**Photo Report**  
**Babe Herman Little League Field**  
**Programs, Services, and Activities**

**Finding:** The Babe Herman Little League Field, located at 1726 Canada Boulevard in Glendale California, was inspected by Disability Access Consultants, Inc., on June 12, 2007.

**Path of Travel to the Stage in the Dad's Club**

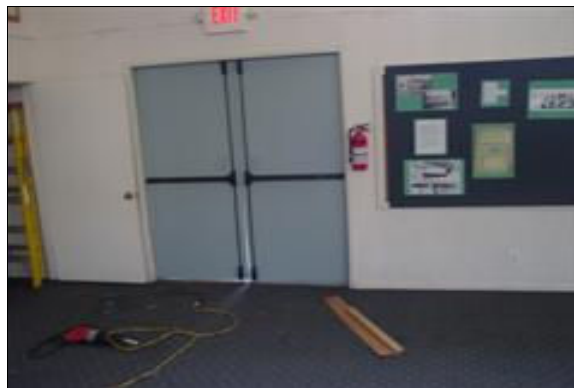
**Finding:** There are only stairs to the primary functions provided on the stage in the Dad's Club, preventing access to individuals with mobility impairments.

**Full Rec:** Install a vertical platform lift to provide a direct path between the stage and level seating area in the Dad's Club, allowing individuals with mobility impairments to participate in programs, services and activities provided by the facility on the stage. The ADA mandates accessibility to programs, services and activities which serve the public.

**Interior Stairs to the Stage in the Dad's Club**

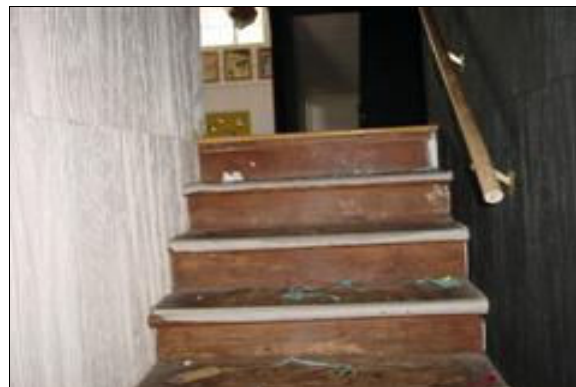
**Finding:** The width of the interior stairway is less than 36 inches.

**Full Rec:** Install an interior stairway with a minimum width of 36 inches (see CBC 1006.2).
